OXFORDSHIRE
STRATEGIC RAIL FREIGHT INTERCHANGE

Chapter 3: Transport
Appendix 3.1: Transport Assessment Part 10 of 11 – Appendices 35 to 43

M40 J9 HIGHWAY DESIGN REVIEW

Project	**Oxfordshire Strategic Rail Freight Interchange (OxSRFI)**		
Document Number	OxSRFI-BWB-GEN-XX-RP-CH-0015	**BWB Ref**	NTH2479
Author	Simon Hilditch	**Status**	S3
Checked	Ryan Picknell	**Revision**	P01
Approved	Simon Hilditch	**Date**	24.03.2026

FIGURE 1 – Location of problems identified in this audit

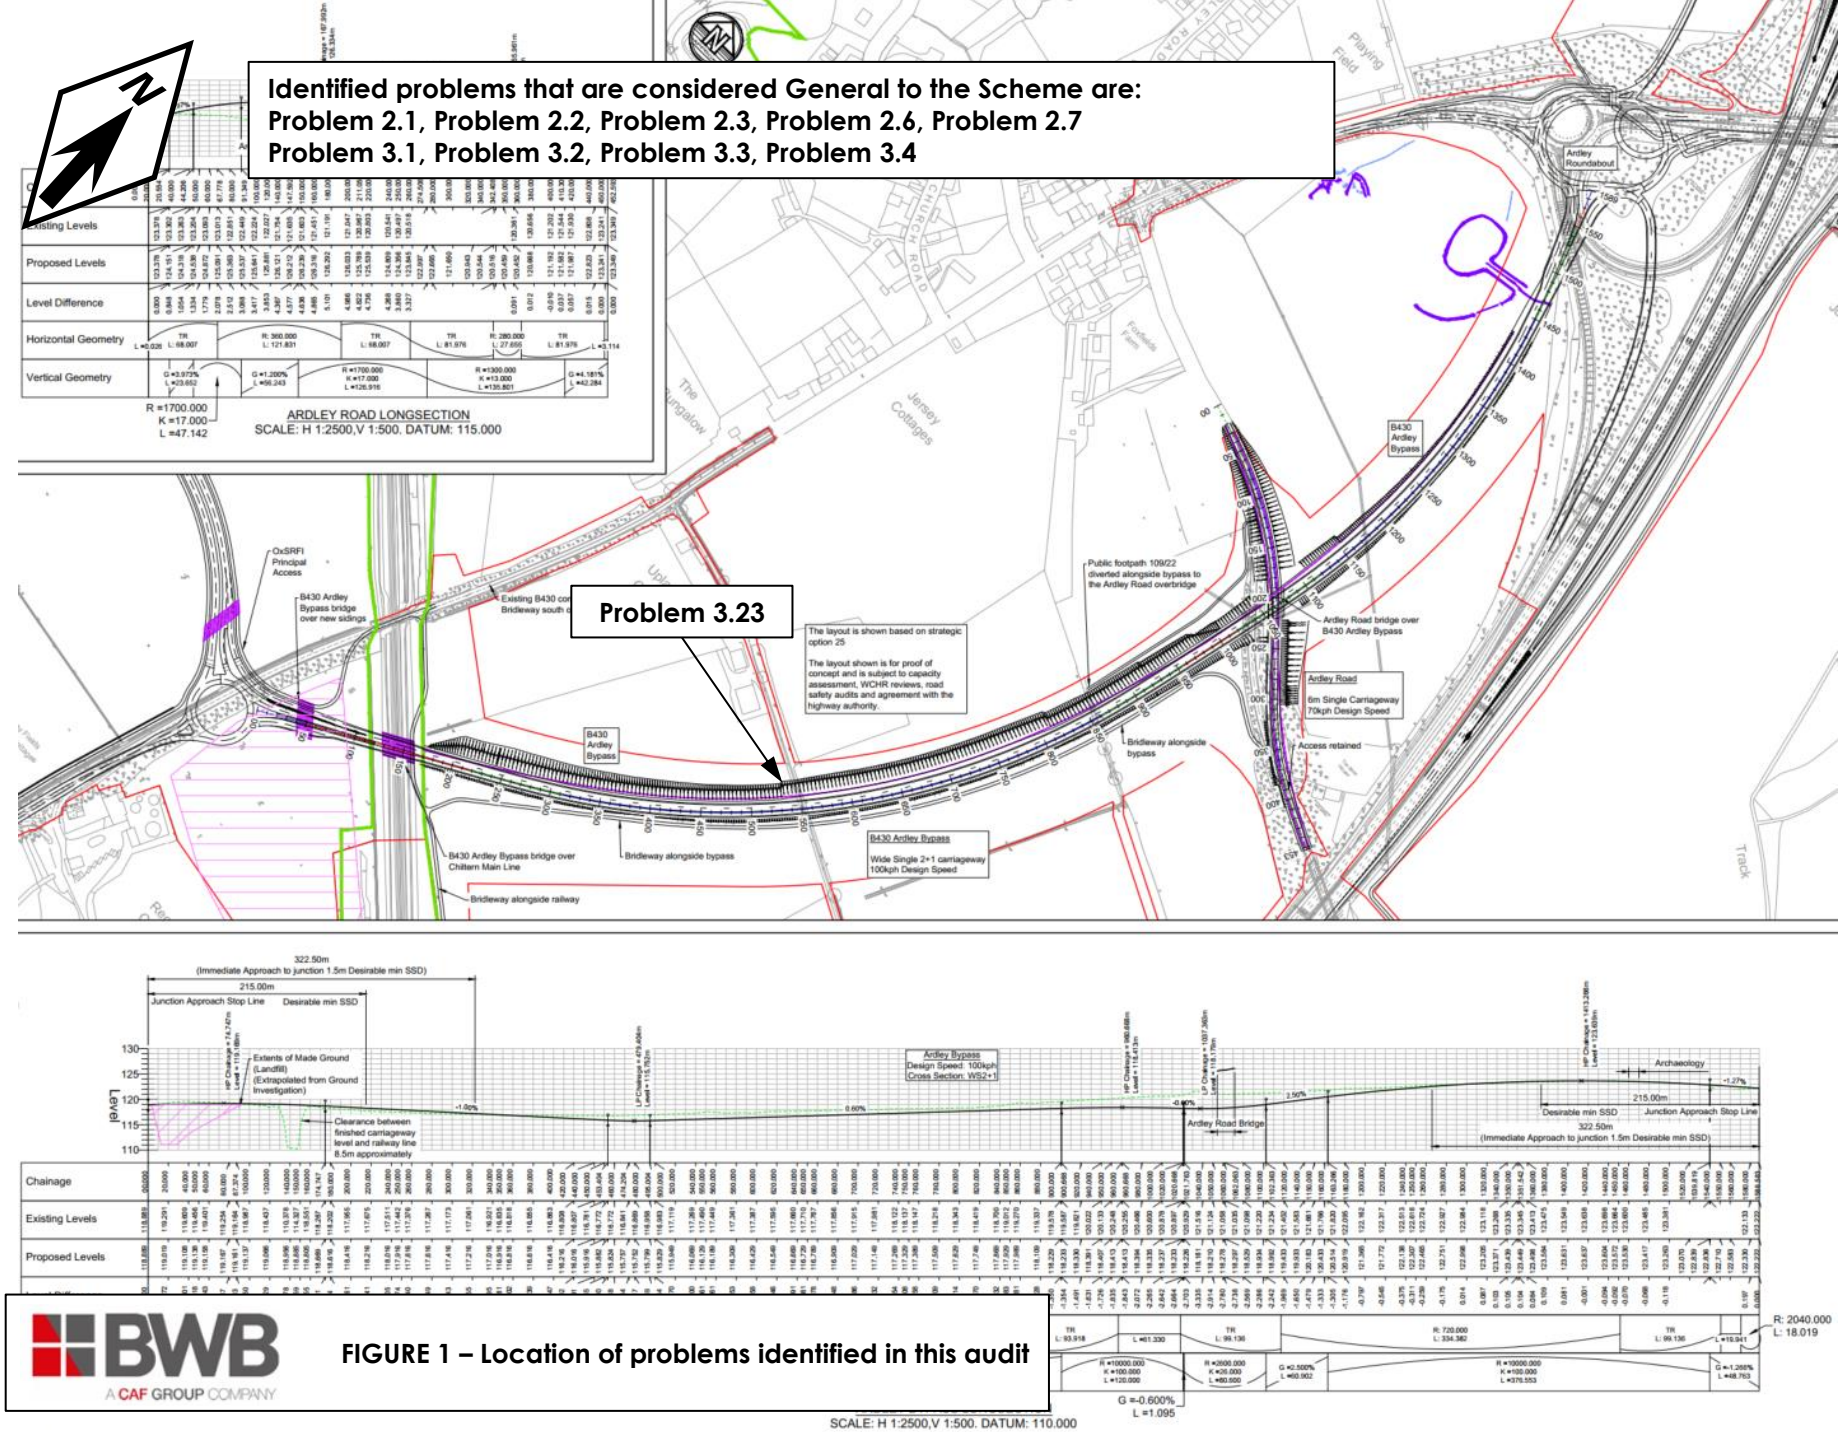
1.5 The terms of reference of the audit are as described in GG 119. The Audit Team has examined and reported only on the road safety implications of the scheme as presented and has not examined or verified the compliance of the designs to any other criteria. All comments and recommendations refer to the highway proposal drawings and the locations have been indicated on **Figure 1**.

Identified problems that are considered General to the Scheme are:
Problem 2.1, Problem 2.2, Problem 2.3, Problem 2.6, Problem 2.7
Problem 3.1, Problem 3.2, Problem 3.3, Problem 3.4
